UNITED STATES  
NUCLEAR REGULATORY COMMISSION  
WASHINGTON, D. C. 20555

PROJECT: CE System 80+

SUBJECT: PUBLIC MEETING OF DECEMBER 9, 1992, TO DISCUSS THE REVIEW STATUS  
OF THE CE SYSTEM 80+ DESIGN WITH SENIOR MANAGEMENT

FIGURE 1.10.4-1  
EMERGENCY FEEDWATER SYSTEM

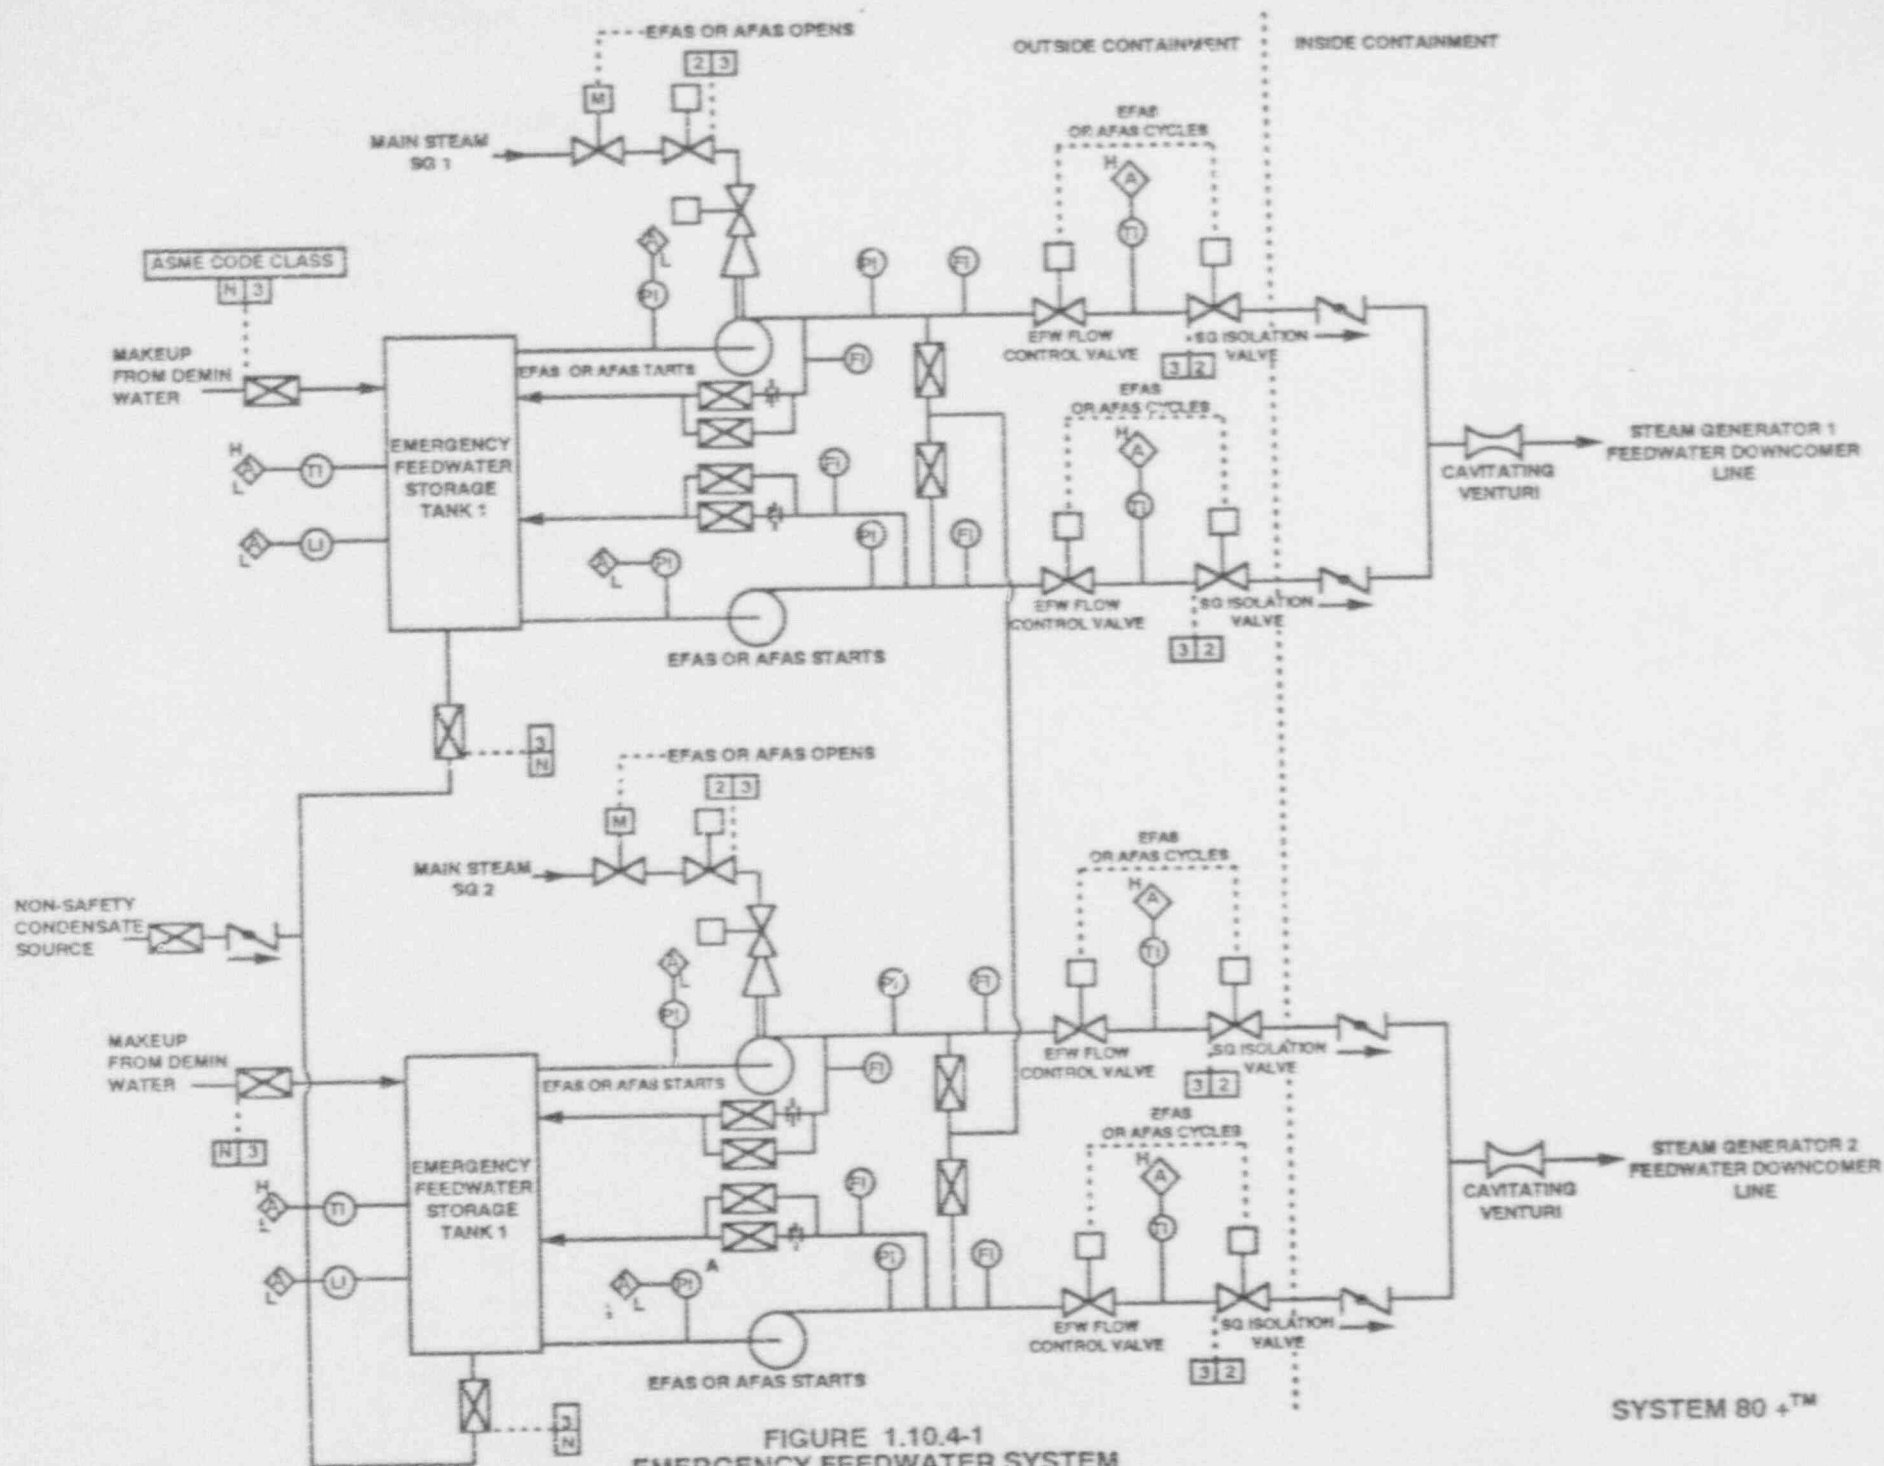
ABB-CE presented the ITAAC for the System 80+ emergency feedwater (EFW) system. The staff commented, in general, that the ABB-CE approach to ITAAC appeared to be a viable and reasonable approach; however, the EFW ITAAC had not been technically evaluated by the staff.

The staff commented that the ITAAC should specify the methodology to determine as-designed and as-built structures, systems, and components (SSC) configuration adequacy. Net positive suction head (NPSH) calculations for EFW and safety inject (SI) pumps were cited by the staff as an example. The staff stated that the methodology should provide the appropriate and standard assumptions and parameters for calculating the available NPSH such as fluid temperature, line loss coefficients, debris levels, room temperatures, etc. Therefore, these standard parameters would permit two engineers to independently arrive at the same conclusion that the NPSH available exceeds the NPSH required.

In addition, the staff commented that the ITAAC should have configuration management provisions for coping with as-built deviations in SSC. The ITAAC should specify the approach and methodology for accommodating said deviations.

Another comment provided by the staff involved the lack of specificity in the ITAAC. Acceptance criteria for the EFW system ITAAC should provide specific information on code class and piping class breaks for pressure retaining components, NDE welding, and ISI requirements. These requirements should cite the appropriate portions of the ASME code. In addition, the certified design commitment (column one of the ITAAC) should be kept more functional and column three should be expanded with the details.
